SUBDIVISION REVIEW SHEET

CASE NO.: C8-2020-0033.1A

SUBDIVISION NAME: Saddle Ridge at Wildhorse Ranch Section 1

CITY OF AUSTIN –DEVELOPMENT SERVICES DEPARTMENT
SUBDIVISION APPLICATION – MASTER COMMENT REPORT

Sheet No.
1 OF 4

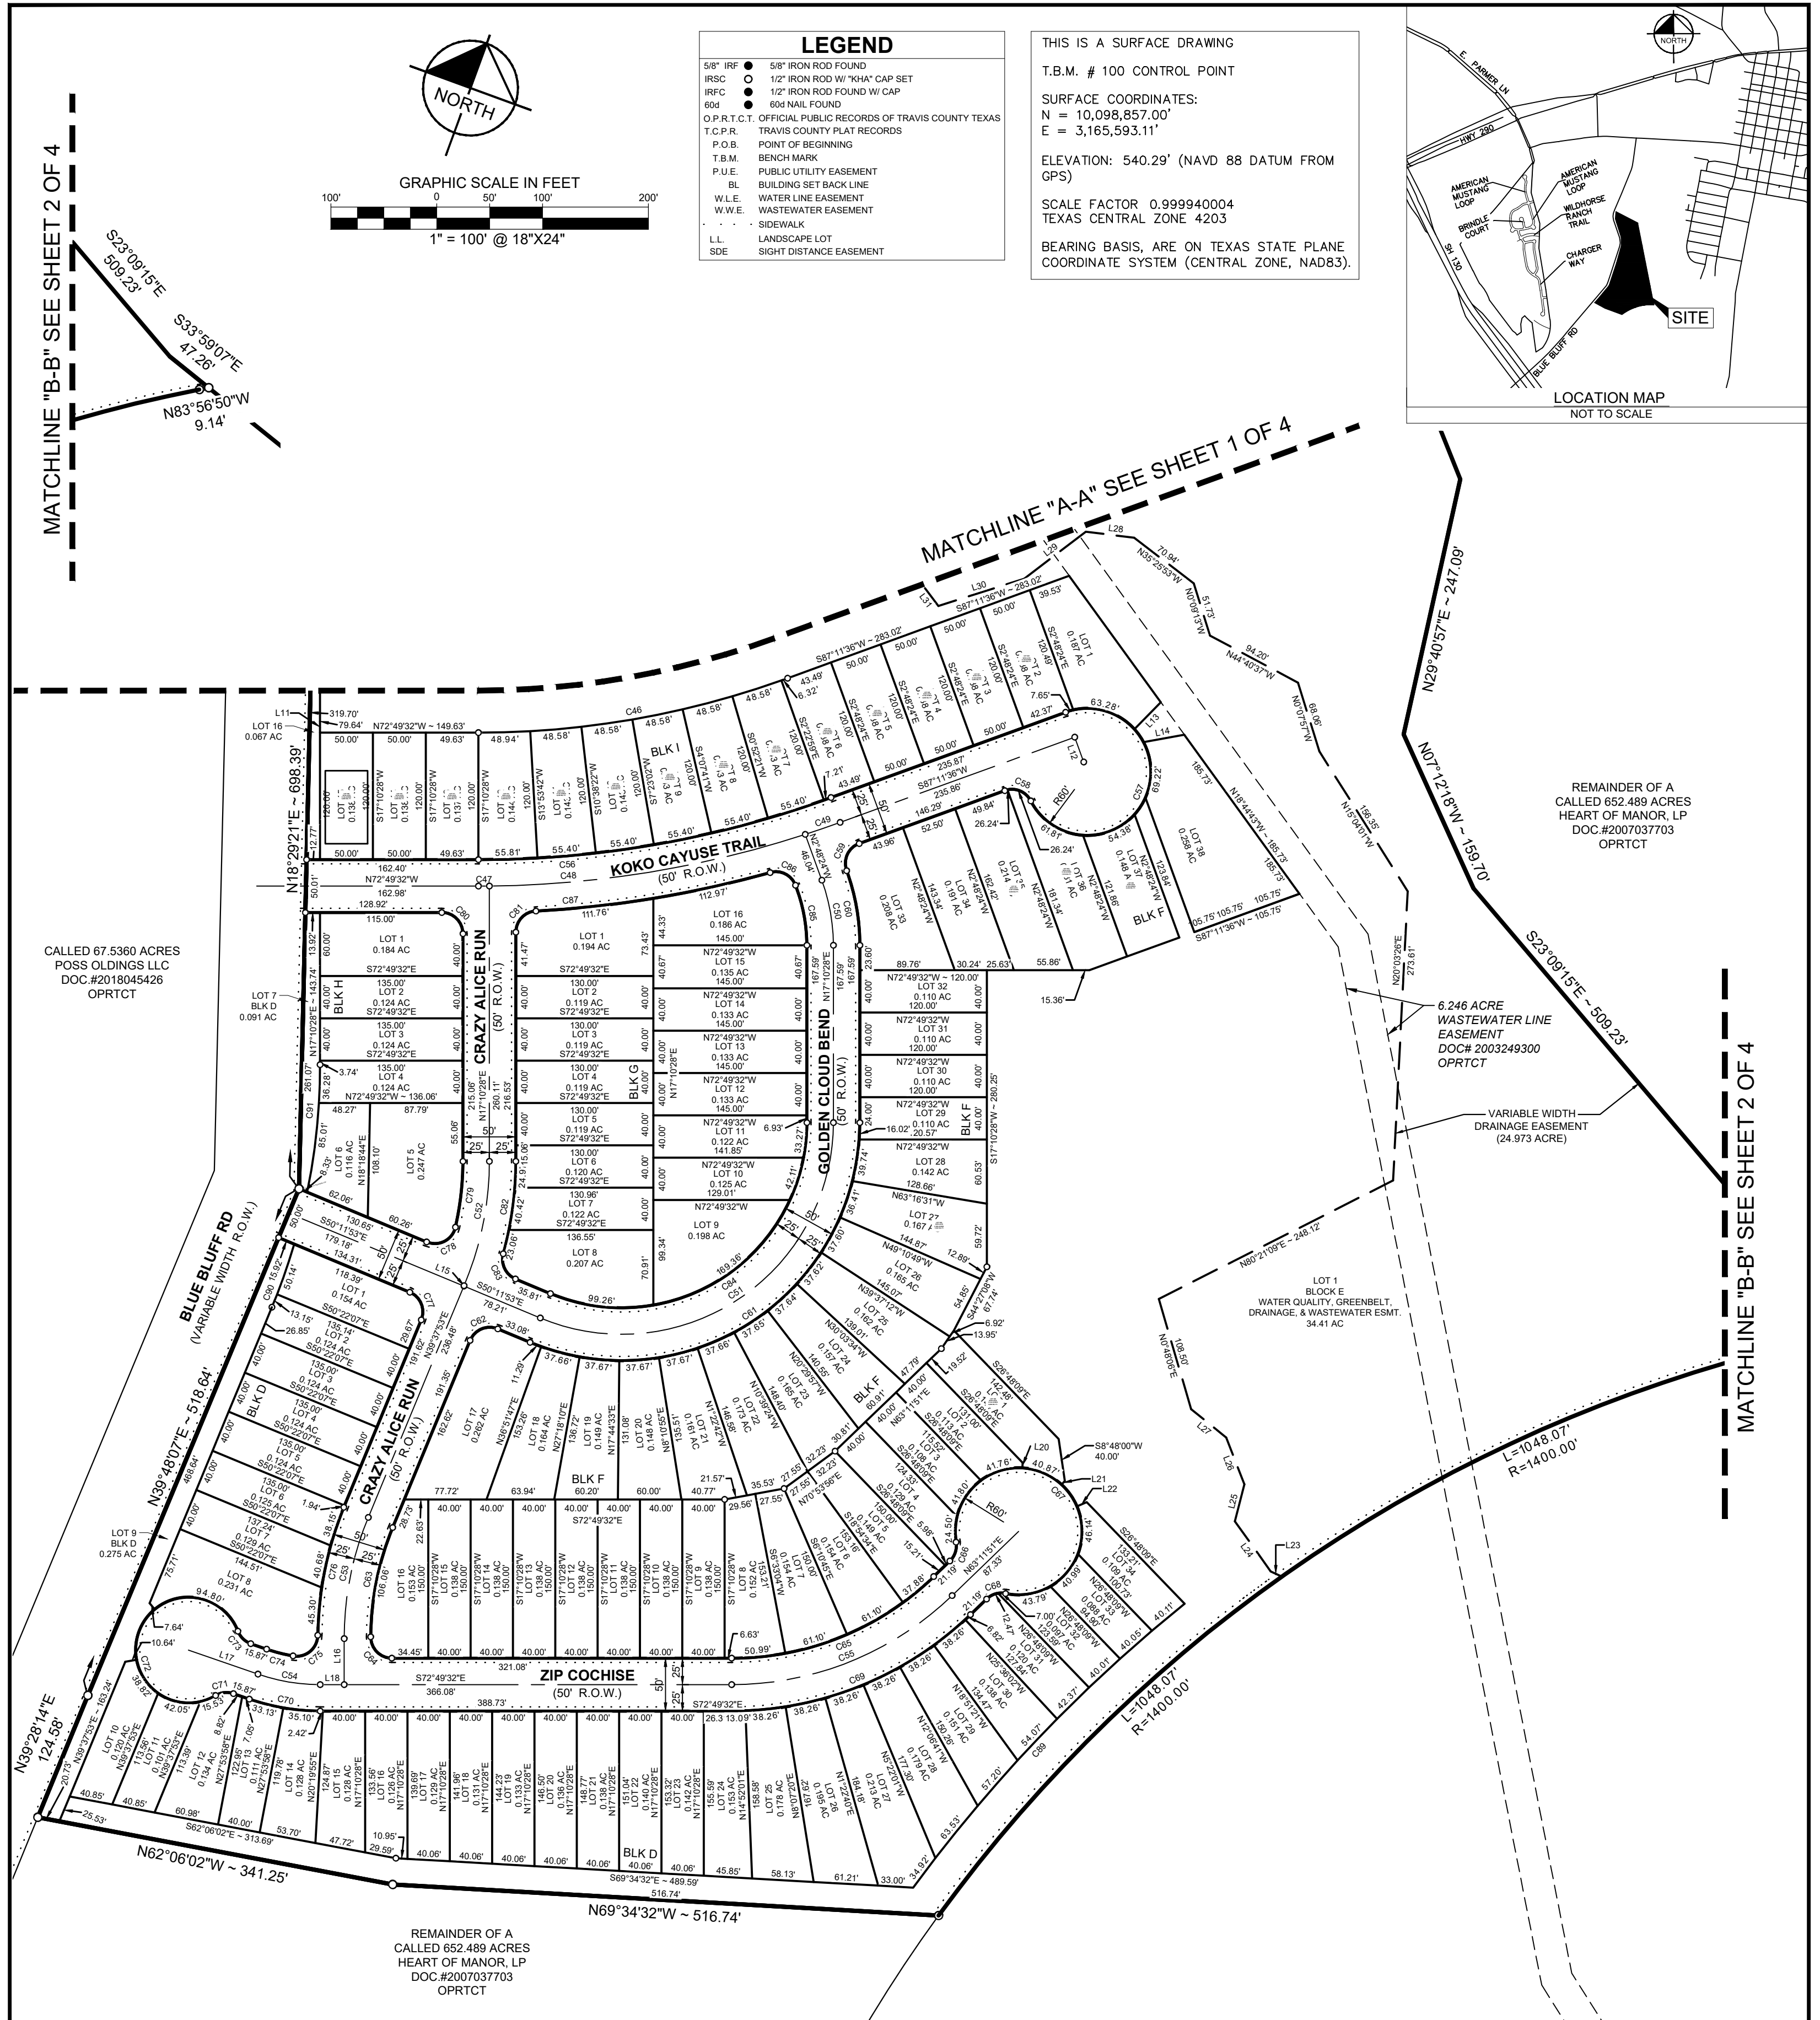
- SR 1. Please place the title at the top of each sheet and ensure that it is at least one-half inch high on each sheet. Also, remove the legal description from underneath the title on each sheet. (LDC § 25-1-83)

- SR 2. Add the case number (C8-2020-0033.1A) to the bottom each sheet. (LDC § 25-1-83)
- SR 3. Please ensure that all text (except what is shown on the face of the plat) is at least 3/32 of an inch. (LDC § 25-1-83)

- SR 4. Remove the “Street Area Summary” table on Sheets 1 through 3. Move the “Lot Summary” table on Sheet 4 to both Sheets 1 and 2. (LDC § 25-1-83)
- SR 5. Fill in any place holder text (ex: XXXXXXXXXX) with the appropriate information. (LDC § 25-1-83)

- SR 6. Please ensure that everything that is referenced in the legend is also shown on the face of the plat and vice versa, including all acronyms and symbols. (LDC § 25-1-83)

- SR 8. Enlarge the labels for the lot numbers. (You could remove the word “lot” in front of each of the lot numbers if more room is needed.) Label the use for all non-residential lots. Move the area amounts for all residential lots into a table on Sheet 3 and include the amounts as square feet instead of acreage. Lastly, it appears that there are overlapping labels – for example, Lots 1 -10, Block J and Lots 1-15, Block I. Please check all labels. (LDC § 25-1-83)

- SR 9. Ensure that the subdivision boundary line is the boldest line. Lot lines and ROW lines should be less bold. (LDC § 25-1-83)
- SR 10. Are all existing and proposed easements for the subdivision shown on the face of the plat? Existing easements must reference the holder of easement and recording information. Are all easements designated on the prelim to be vacated actually vacated now? Example, the 10’ gas easement. (LDC § 25-1-83).
